SAFETY DIRECTIVE AV II – 0004

Replacement of the stock Aeromomentum alternator with Aero Adventure approved replacement.

Figure 1

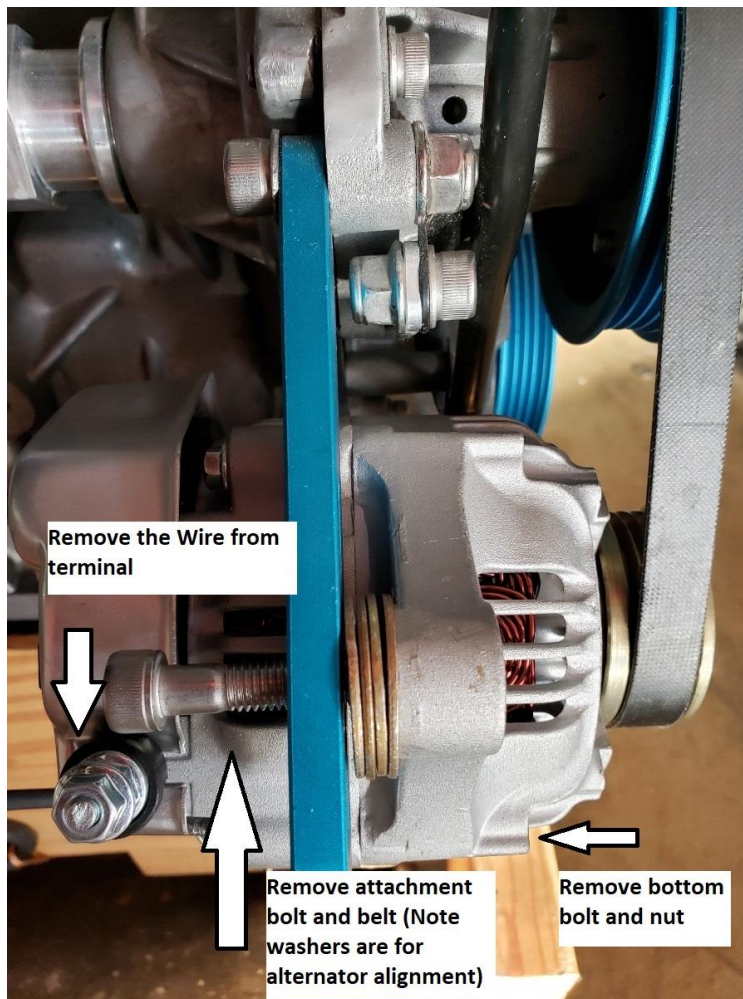
Replacement of the Alternator with the new style offered by Aero Adventure Llc.

Before next flight, Replacement of the Alternator must be conducted according to the Instructions provided in Section 2 of this Safety Directive.

Figure 2

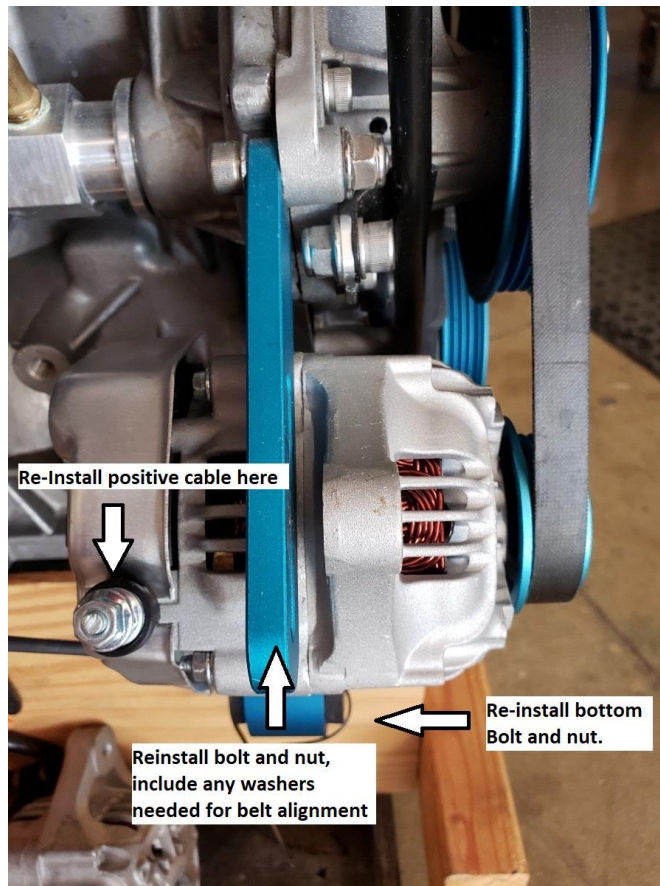
Best practice is to run 8 GA wire from Alternator post through a 60 AMP breaker and directly to positive side of battery. Heavier gauge wire will put too much strain on alternator post which can lead to fatigue and cracking.
